May 9, 2014

MON-00213818-A0

**Re: Project Update – Acadie Avenue/Amirault Street Re-construction, Dieppe, NB
(NBDELG File No. 4561-3-1369)**

Project No.	MON-00213818-A0	
Dwg. No.	FIGURE 9	Rev. No. 0
Scale	1:1000 This drawing is not to be scaled

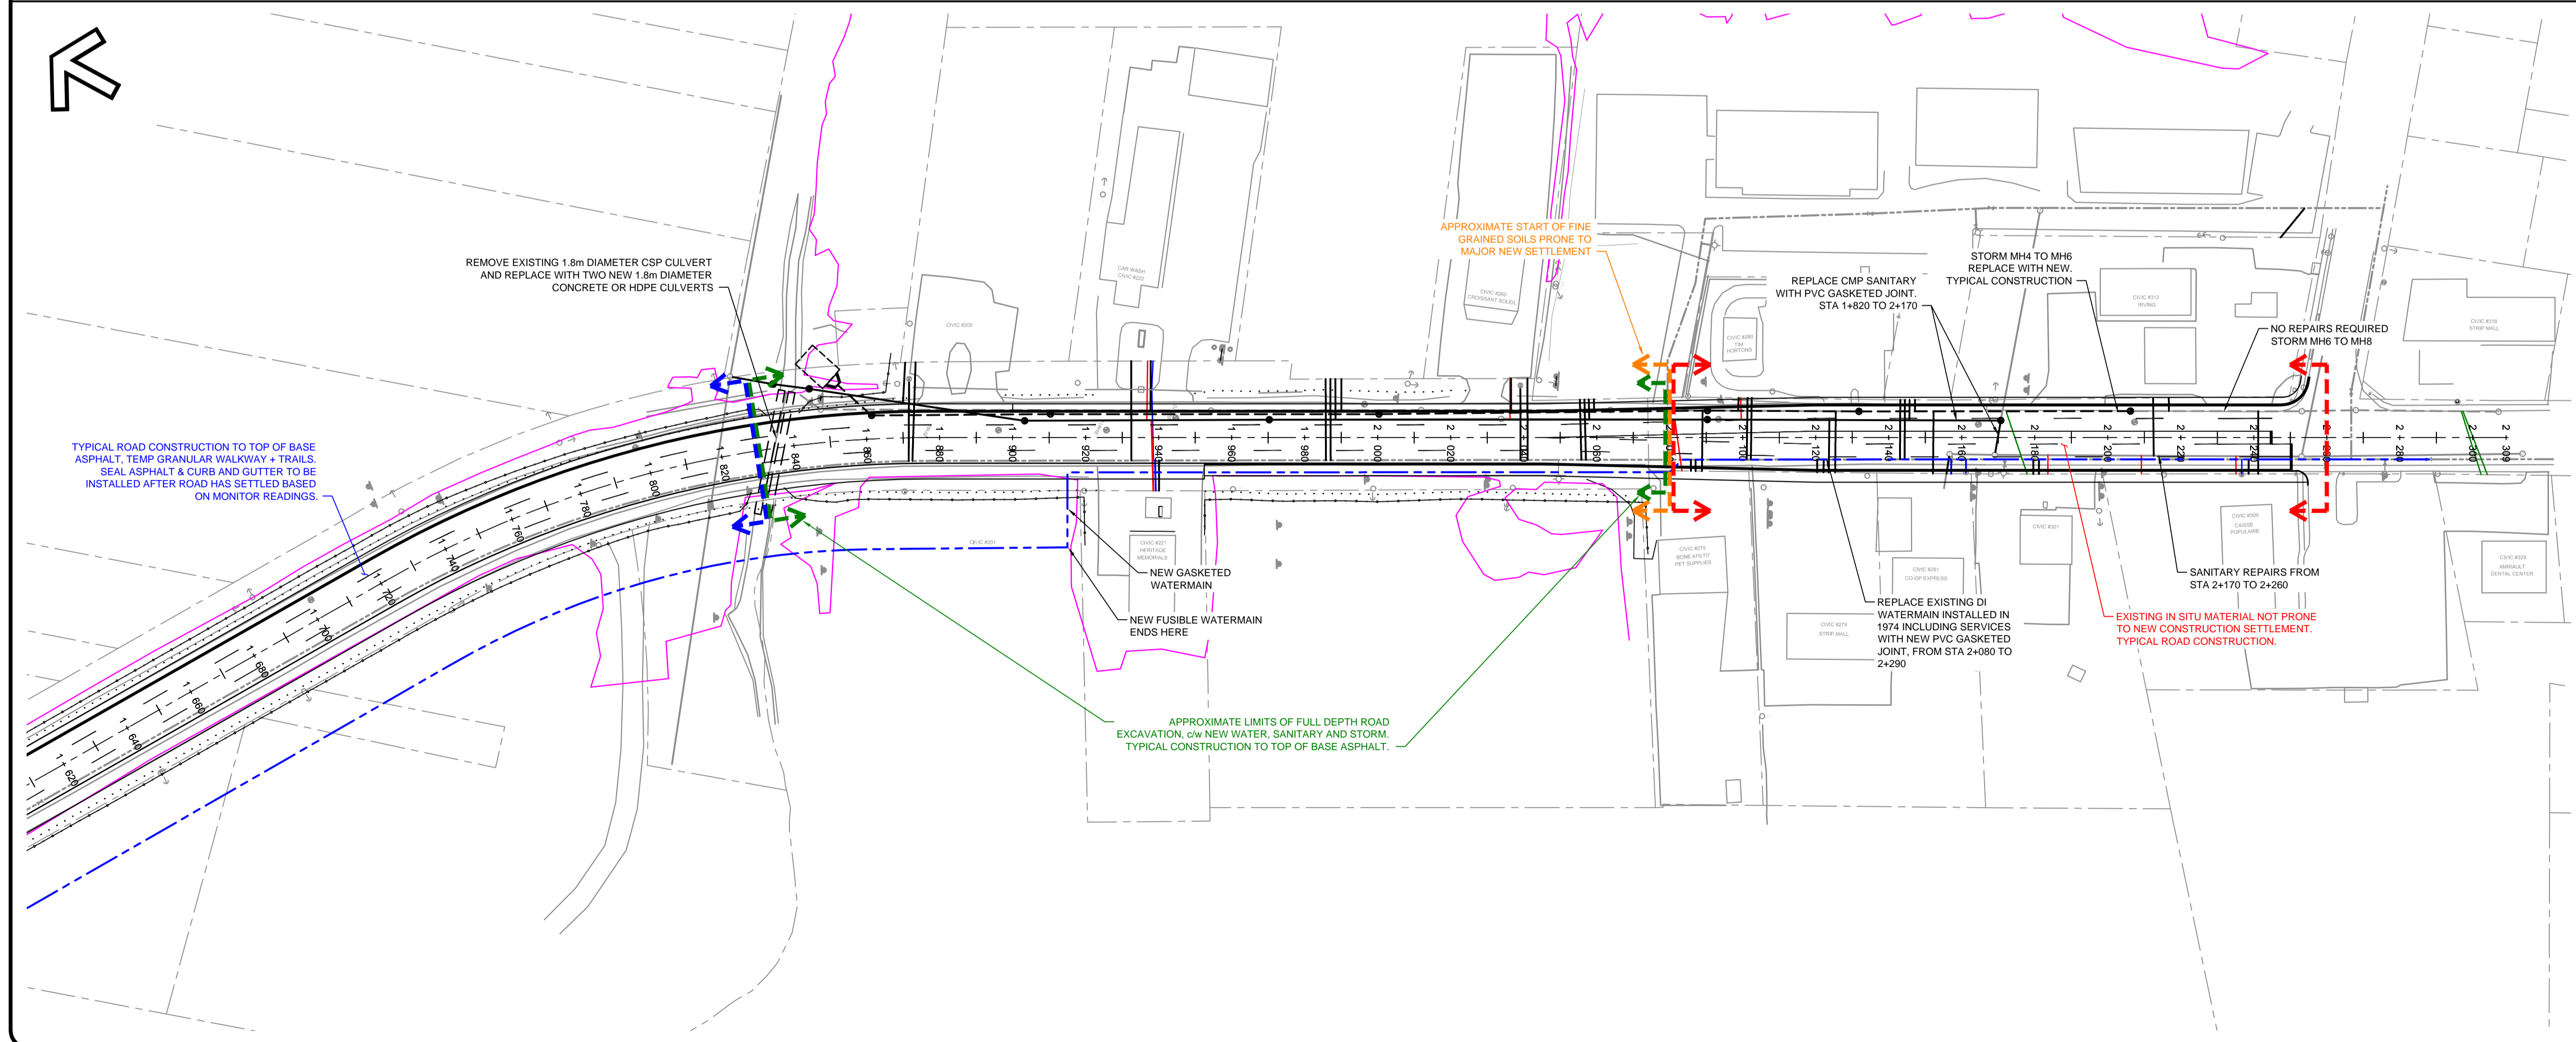
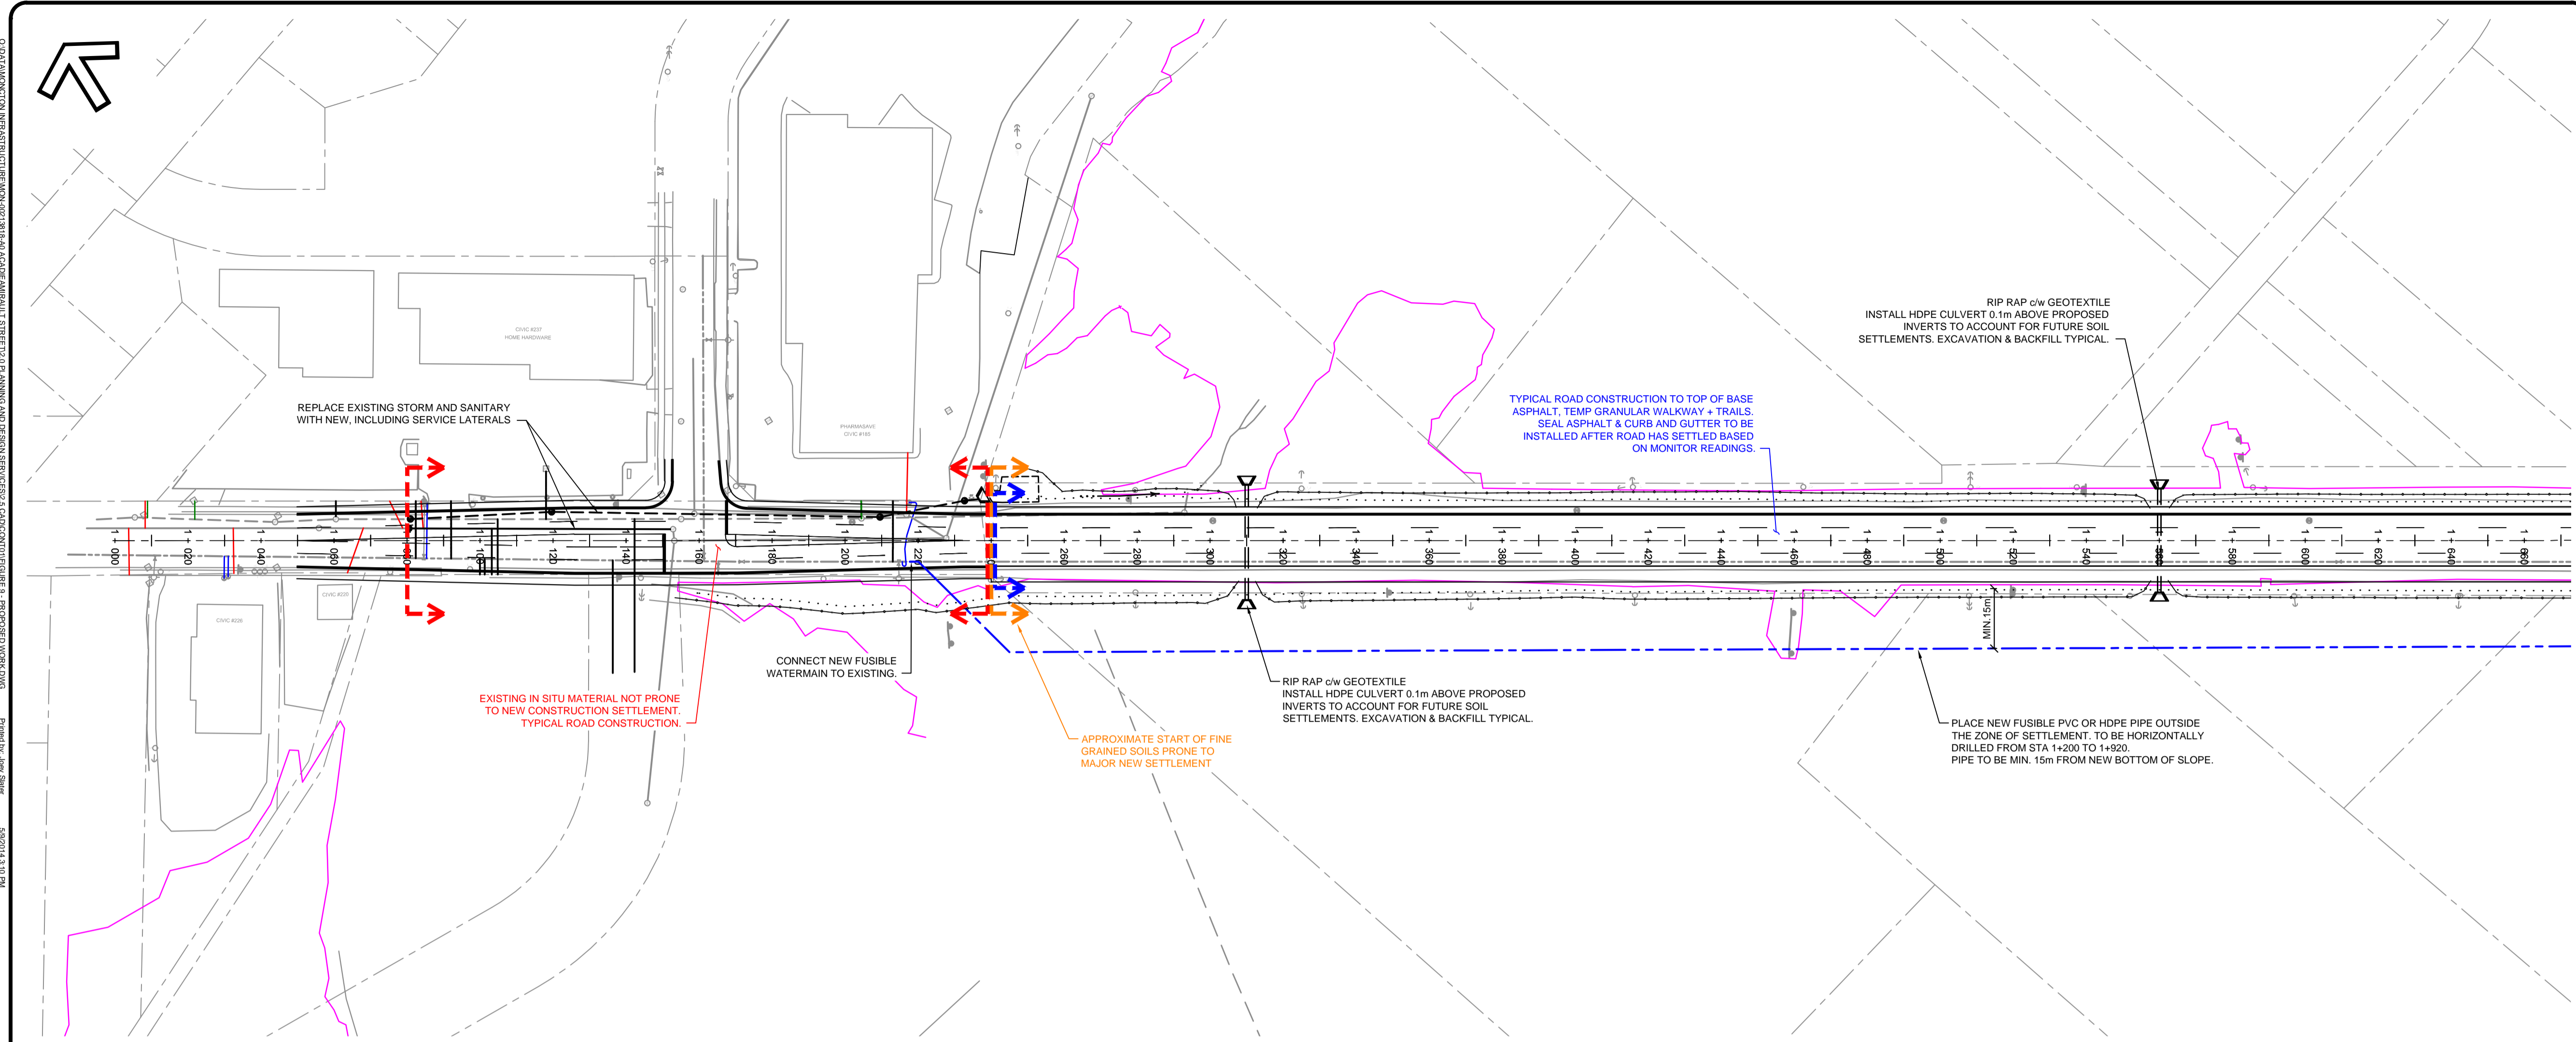
The current design concept which is based upon extensive preliminary design work and the above noted “zoned approach” is illustrated on Figure 9 which is provided in Attachment B. This concept has been selected and approved by the City and the New Brunswick Department of Transportation and

Infrastructure (NBDTI) as the final design concept. As shown on Figure 9, there are three main construction zones.

Typical road construction techniques with no settlement mitigation measures will be employed in Zone 1, which generally incorporates the portions of the roadway outside the marsh and typically underlain by non-settlement prone soils. The two Zone 1 sections roughly extend from Station 1 + 080 to Station 1 + 240 and Station 2 +080 to Station 2 + 260.

Zone 2 extends from about Station 1 + 240 to Station 1 + 830 and is underlain by settlement prone soils of varying type and thickness. Wick drains will be installed in this zone to significantly expedite the consolidation settlements induced by raising the roadway grade to the design elevation. A settlement monitoring program will be employed to monitor the temporal and spatial variation in post-construction roadway settlement in this section. Other than the wick drains, typical road construction will be employed to the top of base asphalt in this section. More settlement prone construction elements such as the seal asphalt layer would be installed after the majority of the consolidation settlements have been realized based upon the field monitoring data. During the interim period, roadway maintenance would be required to address the effects of differential settlement. In addition, new watermain will be installed in the marsh area outside the zone of influence of the surcharge induced embankment settlements by the horizontal directional drilling (HDD) method as noted above.

Full depth road excavation and replacement of the more settlement prone soils will take place in Zone 3 which extends from approximately Station 1 + 830 to 2 + 080. Since the Contractor will be required to maintain a minimum of two lanes of traffic during construction, a temporary access road may be required for a portion of this section of roadway due to the requirement for relatively deep excavation. For areas where a temporary access road is not employed and construction is confined to the limits of the existing roadway footprint, near vertical excavations complete with trench boxes and/or shoring systems to protect workers will be required as per typical construction practice. In these areas, one half the roadway would be re-constructed at a time such that two of the existing Acadie/Amirault travel lanes would remain open to traffic. Concrete barricades would be placed between the two halves of the roadway to protect both the travelling public and construction workers. As previously noted, the Contractor will decide upon the best technical and economic approach to construction including whether or not a temporary access road is required.
